Metropolitan Planning Commission

Staff Reports

April 10, 2025

Figure 1: UDO Regulating Plan

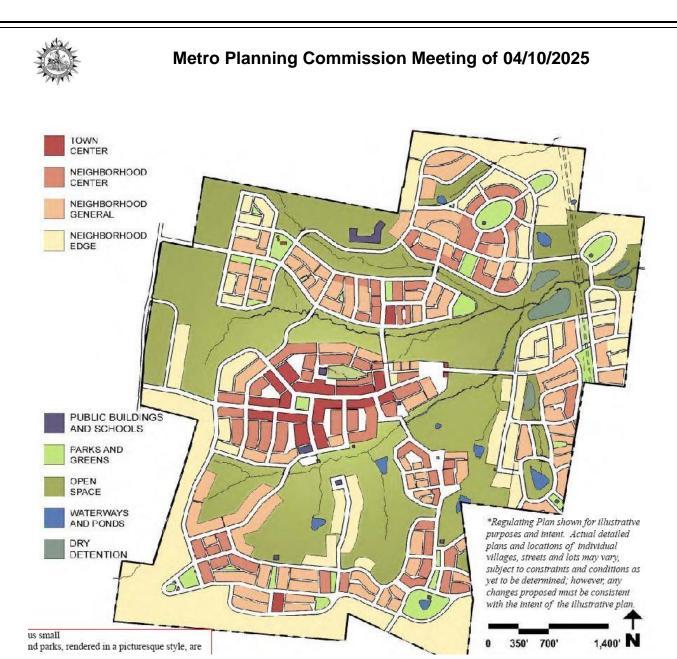
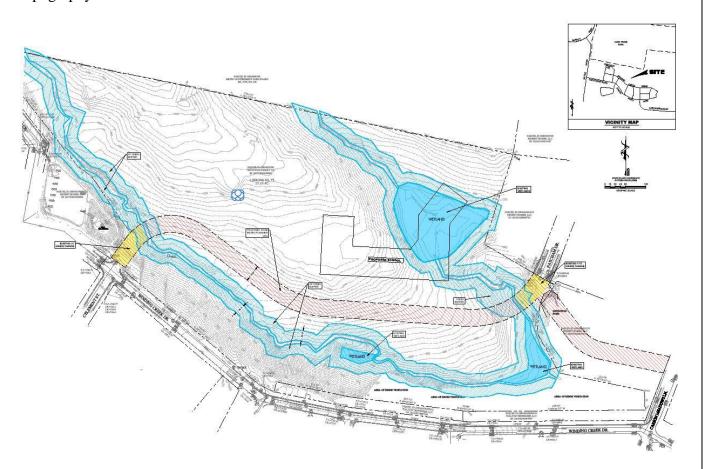
The Regulating Plan on page 34 of the UDO calls out general land uses, open spaces, waterways, and road alignments with the following note:

Regulating Plan shown for illustrative purposes and intent. Actual detailed plans and locations of individual villages, streets, and lots may vary, subject to constraints and conditions as yet to be determined; however, any changes proposed must be consistent with the intent of the illustrative plan.

The subject property has substantial topography and sensitive ecological features with a creek, wetlands, and a 30' stream buffer encircling the site to the west, south, and eastern property edges. These features are regulated by The Tennessee Department of Environmental Conservation and Metro Water Services. The original road alignment through the site connected from Clements Street at the southwest boundary to Patcham Drive at the northeastern boundary. The elevation change at Clement Street is 26 feet from the street elevation to the stream centerline and 20' from Patcham Drive from the street elevation to stream centerline. Significant grading and land disturbance would be needed to accommodate both bridges over the wetlands and stream given the existing topography.

Figure 4: Proposed Road Alignment Cross Section at Fairchild Circle

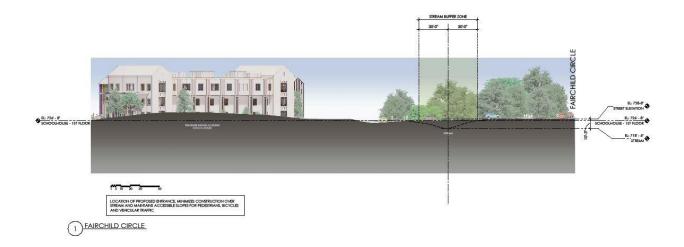
The proposed major modification is to relocate the access road to connect to Fairchild Circle as per Figure 3 below, which is a grade change of 10'-3" and to not connect through to Patcham Drive.
